FINAL
MONITORING REPORT
YEAR 2 (2019)
MUD LICK CREEK MITIGATION SITE

RE: Mud Lick Creek Monitoring (DMS Project # 93482, Contract #7683)
Final MY2 (2019) Annual Monitoring Report

Axiom Environmental, Inc. (AXE) is pleased to provide you with one hard copy and a CD of digital files for the Final Mud Lick Creek MY2 (2019) Annual Monitoring Report. We received your comments via email on January 9, 2020 and have addressed them as follows:

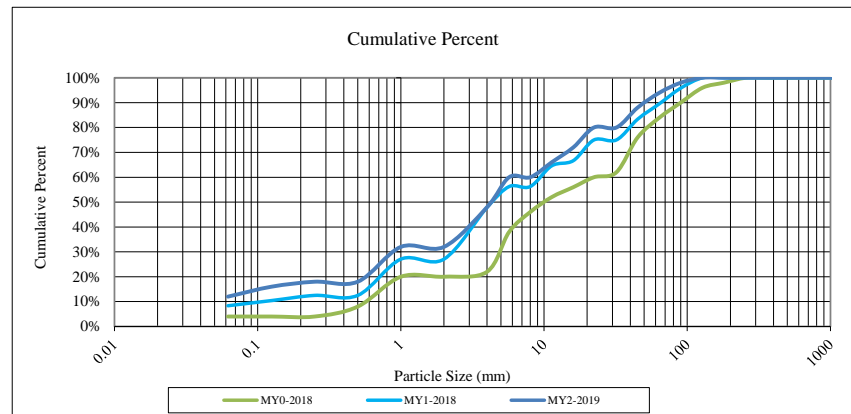
- e. The cross sections identified on the pebble count charts appear to be incorrect.

The cross-section labels were updated on the pebble count charts.
